Project	IEEE 802.16 Broadband Wireless Access Working Group < http://ieee802.org/16 >	
Title	H-ARQ support corrections, for OFDMA PHY mode	
Date Submitted	2004-04-28	
Source(s)	<p>Panyuh Joo, Seungjoo Maeng, Jaeho Jeon, Soonyoung Yoon, Jeong-Heon Kim, Jaehyok Lee, Myungkwang Byun, Inseok Hwang, Jaehee Cho, Jiho Jang, Sanghoon Sung, Geunhwi Lim, Hong Sung Chang, Yong Chang, JungWon Kim, TaeWon Kim Samsung Electronics Co. Ltd.</p> <p>Yigal Leiba, Zion Hadad, Yossi Segal, Itzik Kitroser Runcom Technologies</p> <p>Choongil Yeh, Hyoungsoo Lim, Yuro Lee, Jongee Oh, DongSeung Kwon, ETRI</p> <p>panyuh@samsung.com yigall@runcom.co.il lim@etri.re.kr</p>	
Re:	Sponsor re-circulation Ballot	
Abstract	H-ARQ support corrections, for OFDMA PHY mode	
Purpose	Adoption of proposed changes into P802.16-REVd/D4-2004	
Notice	This document has been prepared to assist IEEE 802.16. It is offered as a basis for discussion and is not binding on the contributing individual(s) or organization(s). The material in this document is subject to change in form and content after further study. The contributor(s) reserve(s) the right to add, amend or withdraw material contained herein.

In page 529, line 47, correct s

Figure 240—CTC encoder

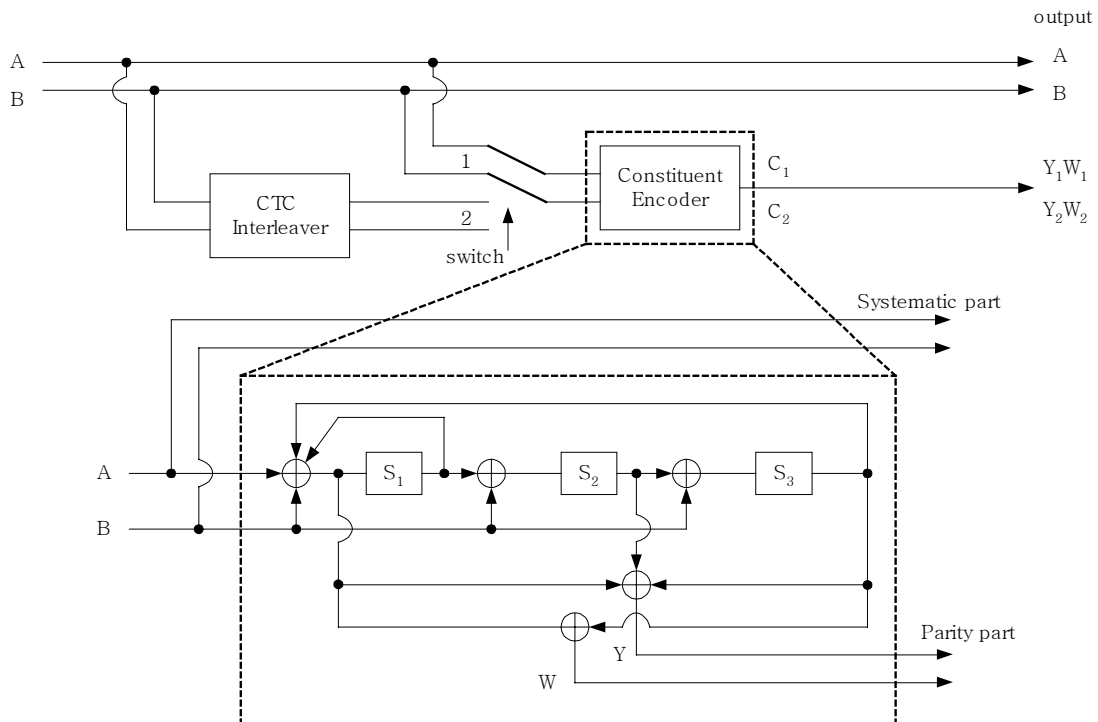
The Convolutional Turbo Code defined in this section is designed to enable support of hybrid ARQ (H-ARQ). H-ARQ implementation is optional. The Convolutional Turbo Code encoder, including its constituent encoder, is depicted in Figure 240. It uses a double binary Circular Recursive Systematic Convolutional code. The bits of the data to be encoded are alternately fed to A and B, starting with the MSB of the first byte being fed to A. The encoder is fed by blocks of k bits or N couples ($k = 2 * N$ bits). For all the frame sizes k is a multiple of 8 and N is a multiple of 4. Further N shall be limited to: $8 \leq N/4 \leq 1024$.

First, the encoder (after initialization by the circulation state Sc_1 , see 8.4.9.2.3.3) is fed the sequence in the natural order (position 1) with the incremental address $i = 0 .. N-1$. This first encoding is called Sc_1 encoding. Then the encoder (after initialization by the circulation state Sc_2 , see 8.4.9.2.3.3) is fed by the interleaved sequence (switch in position 2) with incremental address $j = 0, \dots, N-1$. This second encoding is called C_2 encoding.

The order in which the encoded bit shall be fed into the [interleaver \(8.4.9.3\)](#) [subpacket generation block \(8.4.9.2.3.4\)](#) is:

Figure 245 — Block diagram of the interleaving scheme

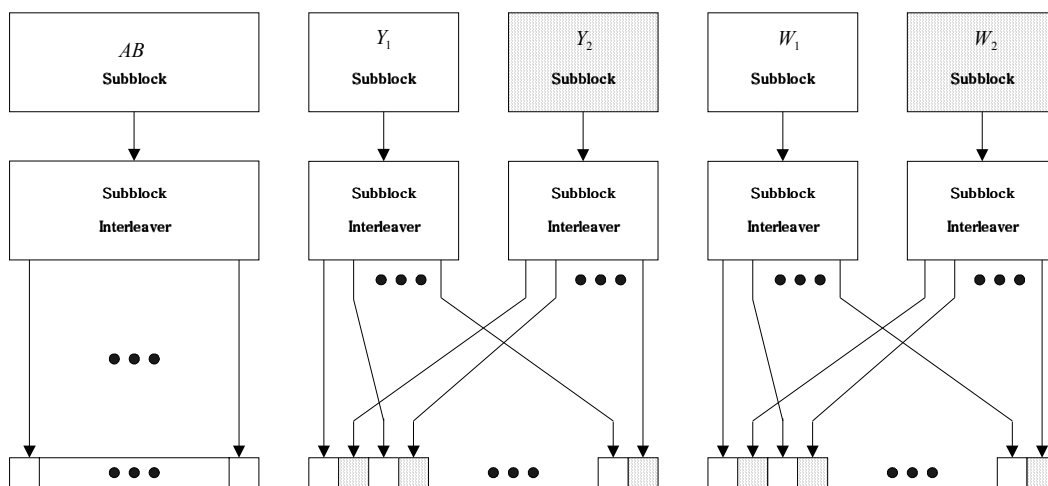
Figure eec245 shows block diagram of the interleaving scheme of the proposed FEC structure. At first, the CTC encoder output is separated into a subblock. Then the interleaving is applied for the bit sequence within the subblock. It guarantees the uniformity of the interleaved codeword. Next, Symbol grouping is performed such that the parity bits from the two constituent encoders are interleaved bit by bit. The systematic part of the 1/3 CTC encoder is located at the head of the interleaved codeword. In this way, the proposed FEC structure ensures the quasi complementary characteristics of the interleaved codeword and thus, complementary characteristics of the subpacket. We just say “quasi-complementary” for the case of breaking the complementariness of few bits after puncturing.

Figure eee – PRBS of the randomizer

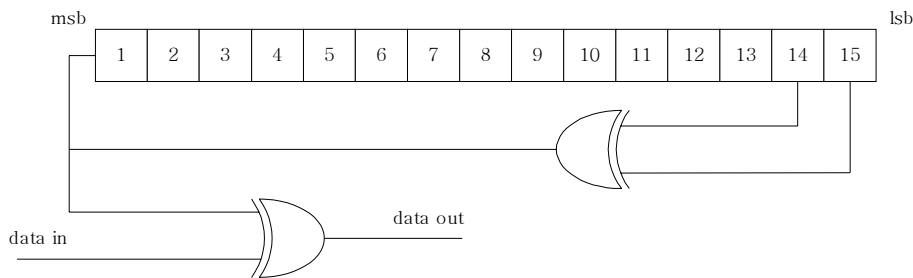
The Pseudo Random Binary Sequence (PRBS) generator shall be $1 + X^{14} + X^{15}$ as shown in Figure eee. Each data byte to be transmitted shall enter sequentially into the randomizer, MSB first. The seed value shall be used to calculate the randomization bits, which are combined in an XOR operation with the serialized bit stream of each burst. The randomizer sequence is applied to the output from the padding block. The bit issued from the randomizer shall be applied to the CRC encoder.

Figure fff – Initialization construction for the PRBS of the randomizer

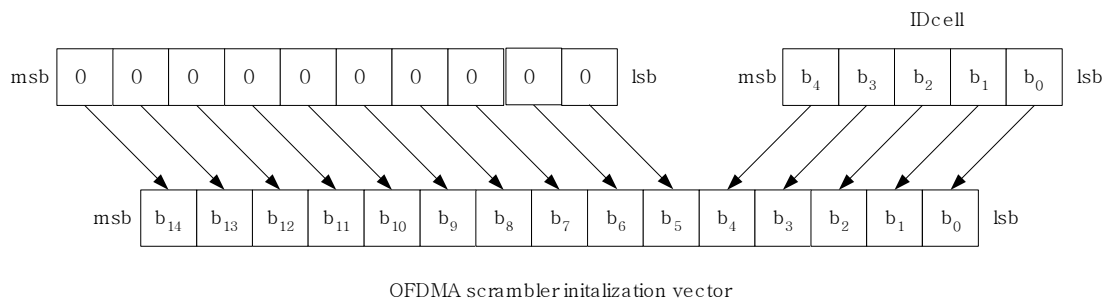
The scrambler is initialized with the vector created as shown in Figure fff. The lowest 5 bits are ID_{cell} or UL_ID_{cell} and the other bits are set '0'.

Figure 125—Construction of H-ARQ encoder packet

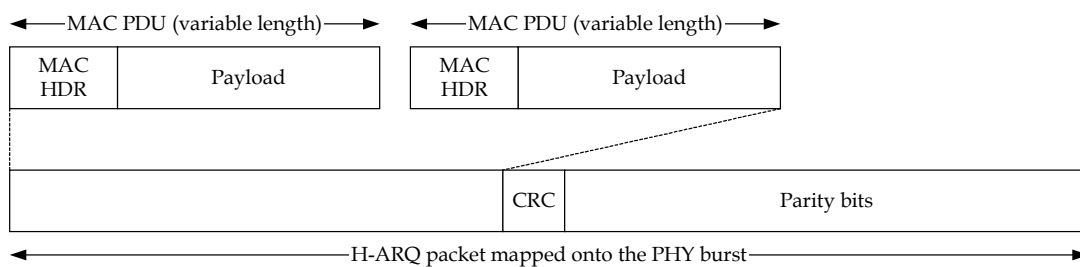
One or more MAC PDUs can be concatenated and an H-ARQ packet formed by adding a CRC to the PHY burst. Figure 125 shows how the H-ARQ encoder packet is constructed.

Figure 1 Reduced CID Decoding

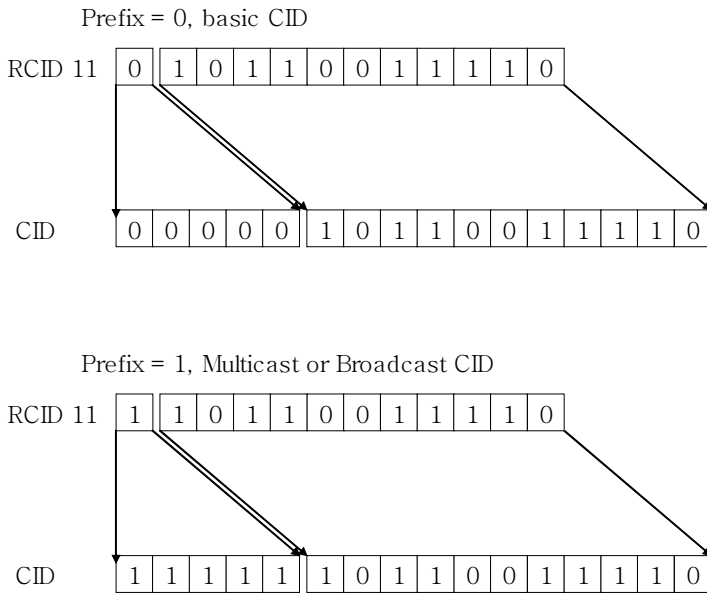
Figure 1 shows the decoding of reduced CID when the RCID_Type is set to 3.

Figure 2 Subchannel allocation modes of Compact DL-MAP_IE for Band AMC

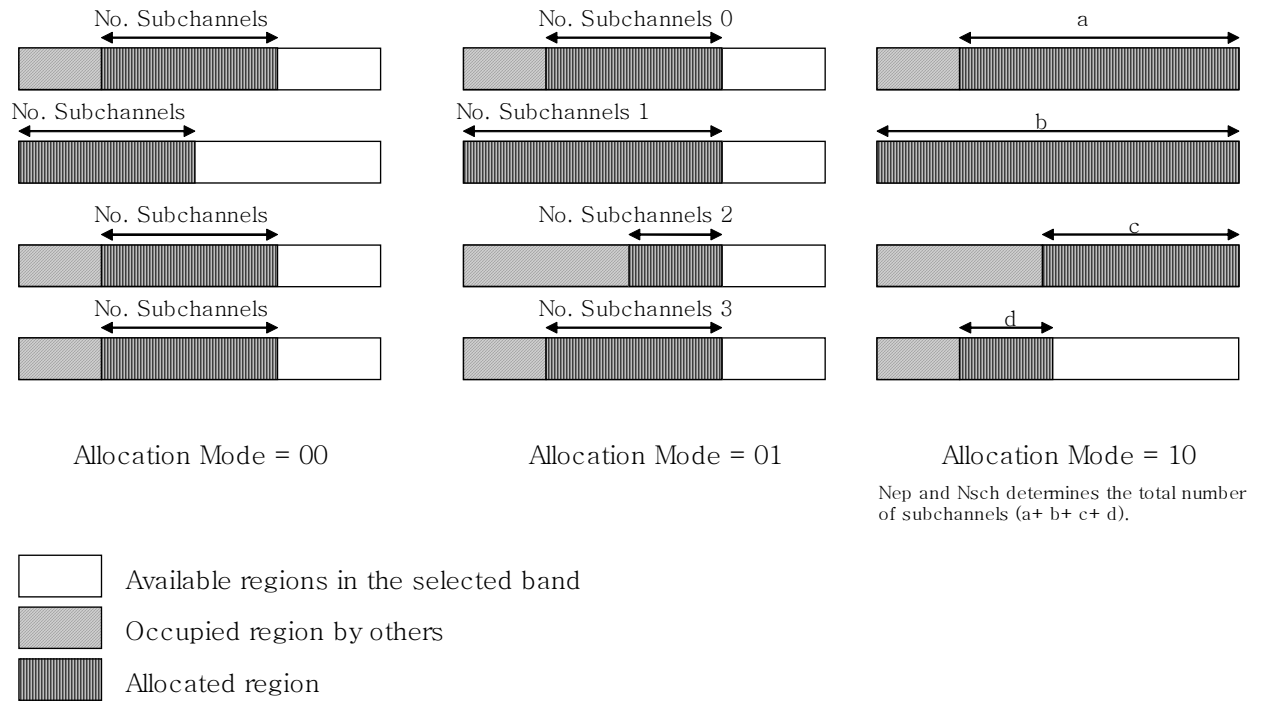
The allocation mode variant is shown in Figure 2.
